**WOKINGHAM
BOROUGH COUNCIL**

SUBMISSION OF DETAILS TO COMPLY WITH CONDITIONS

**LAND SOUTH OF WOKINGHAM, EAST OF FINCHAMPSTEAD ROAD AND WEST OF WATERLOO ROAD,
WOKINGHAM**

**PLANNING PERMISSION 192928 (CONSTRUCTION OF THE SOUTH WOKINGHAM DISTRIBUTOR ROAD (SWDR)
BETWEEN FINCHAMPSTEAD ROAD AND WATERLOO ROAD, INCLUDING A LINK TO HEATHLANDS ROAD,
TOGETHER WITH ASSOCIATED WORKS)**

Condition 5 levels (213441)

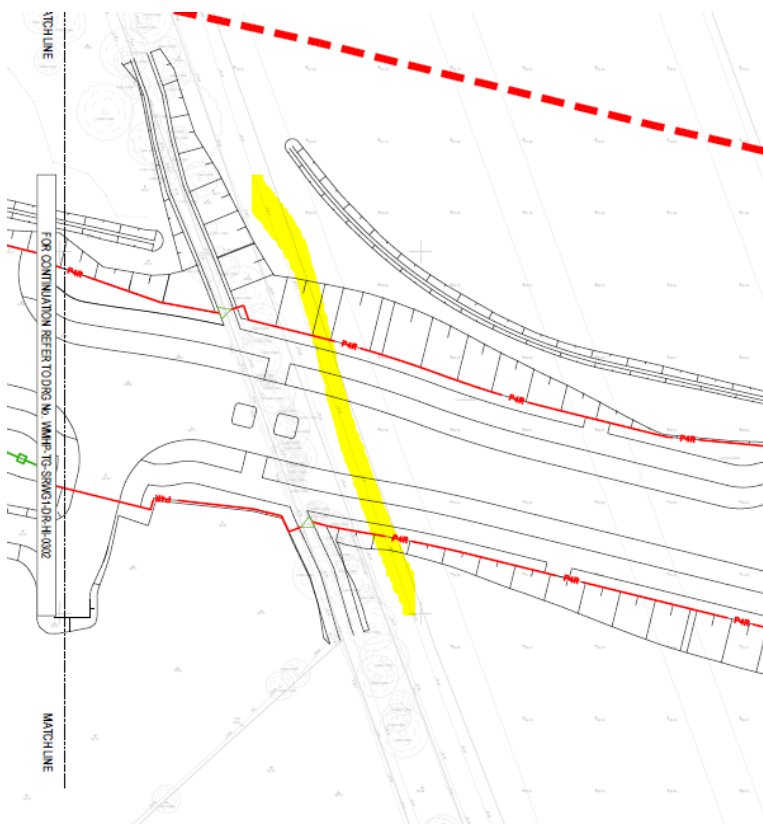
Please provide chainage drawings and longitudinal sections, as provided at the original application stage, showing existing, approved and proposed levels to allow comparison. I am aware that the consortium have raised concerns about the level of the road being increased and need to understand the scope of the issue.

and on WMHP-TG-SRWG1-DR-HI-301:

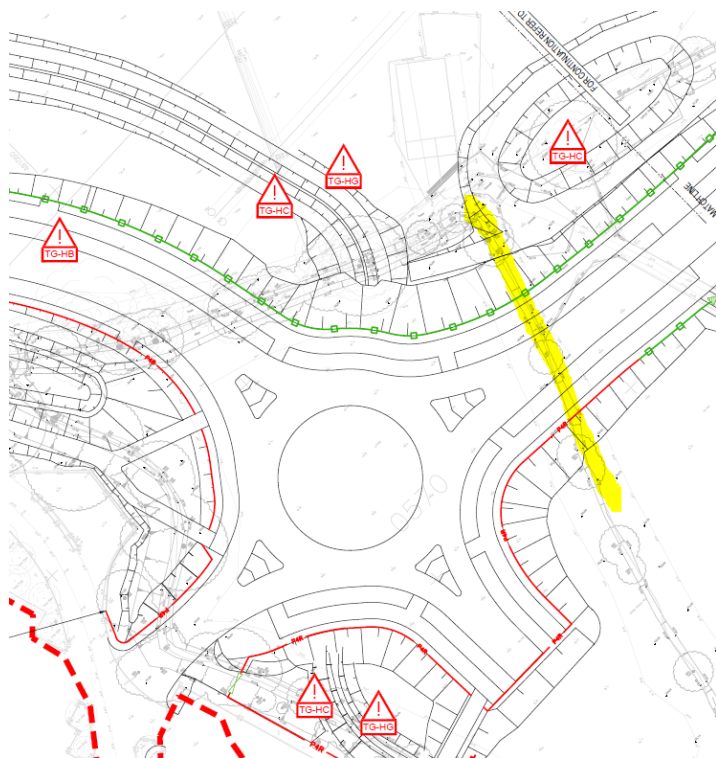
Additional mammal tunnels are required in these two locations, with reference to the fencing plans, on WMHP-TG-SRWG1-DR-HI-0303 (highlighted yellow):

Condition 11 AMS (213554)

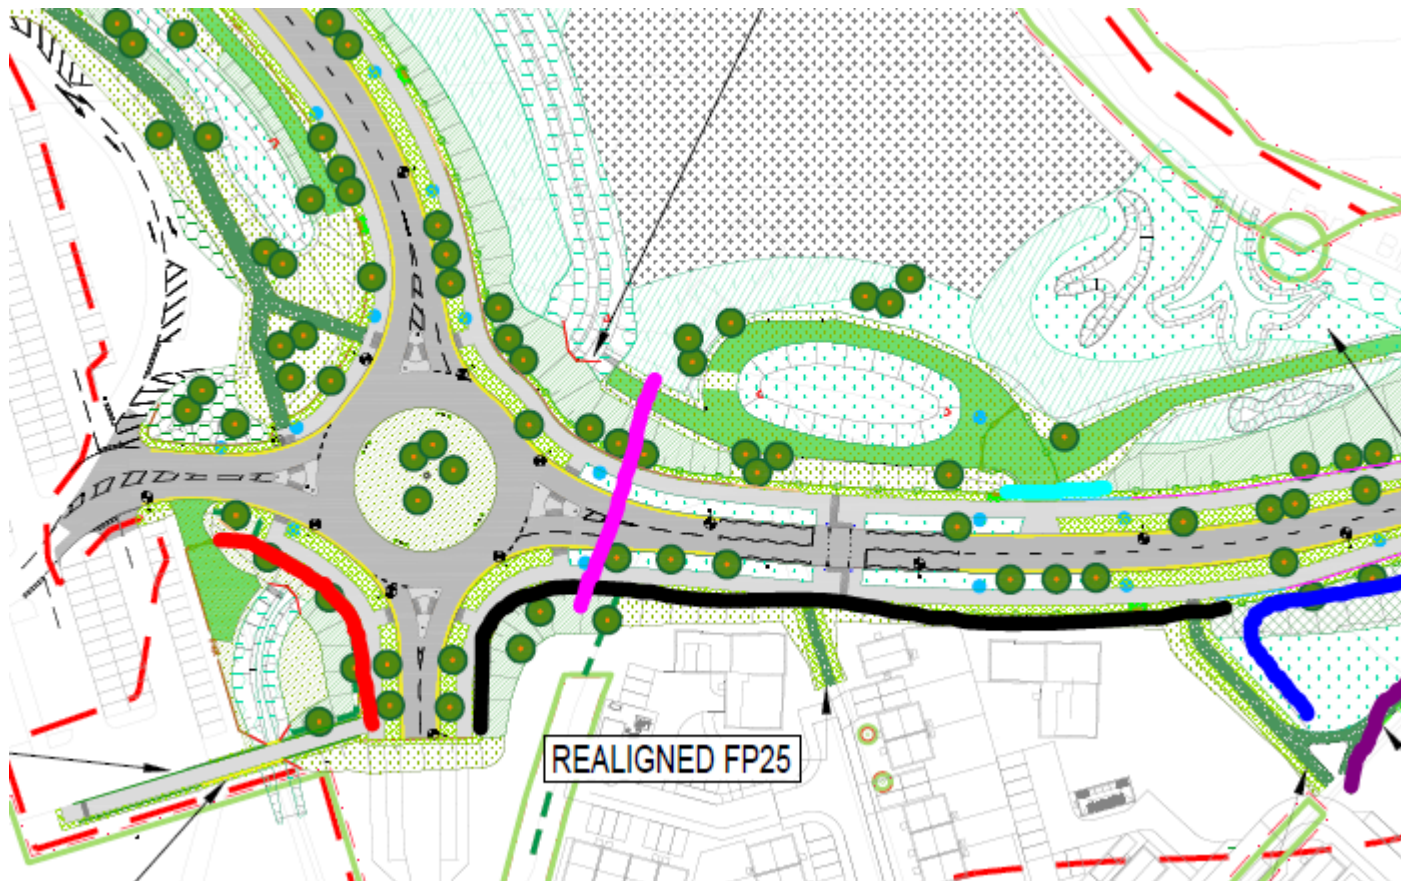
A revised AIA has been submitted but not an AMS which will need to be submitted to comply with this condition.

With reference to the WMHP-TG-SRWG1-DR-LS plans:

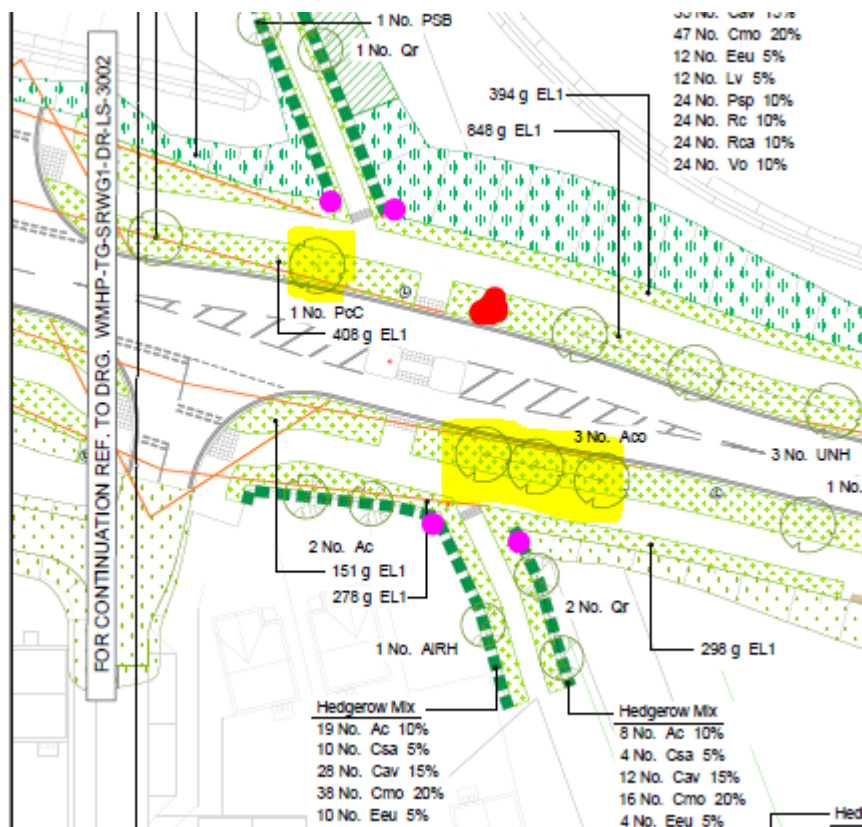
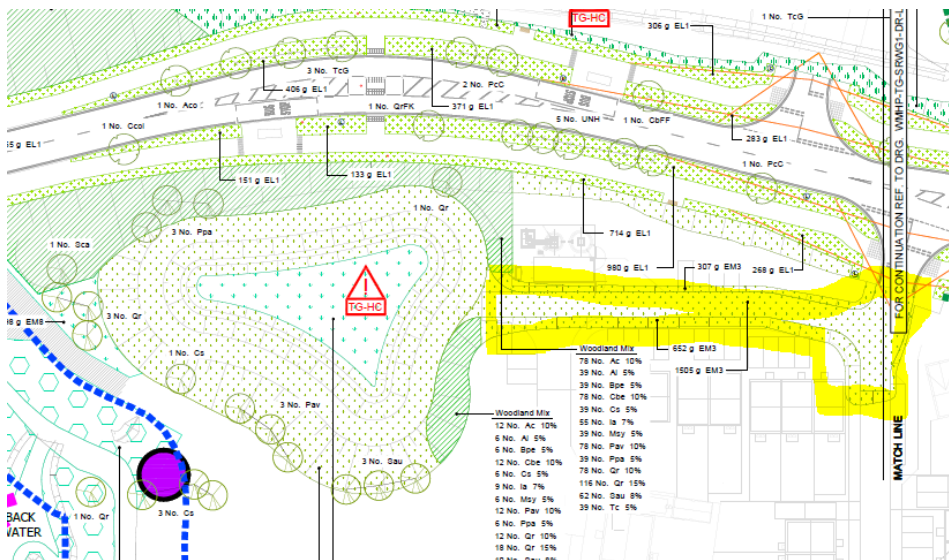
3002 P04 – The access path to the attenuation basin south of the SWDR is shown as being wildflower mix, which will not be the case in the long-term. The treatment of this area should be revised to reflect Persimmon's proposals and avoid the need for the wildflower grassland habitat to be considered in their baseline BNG assessment.
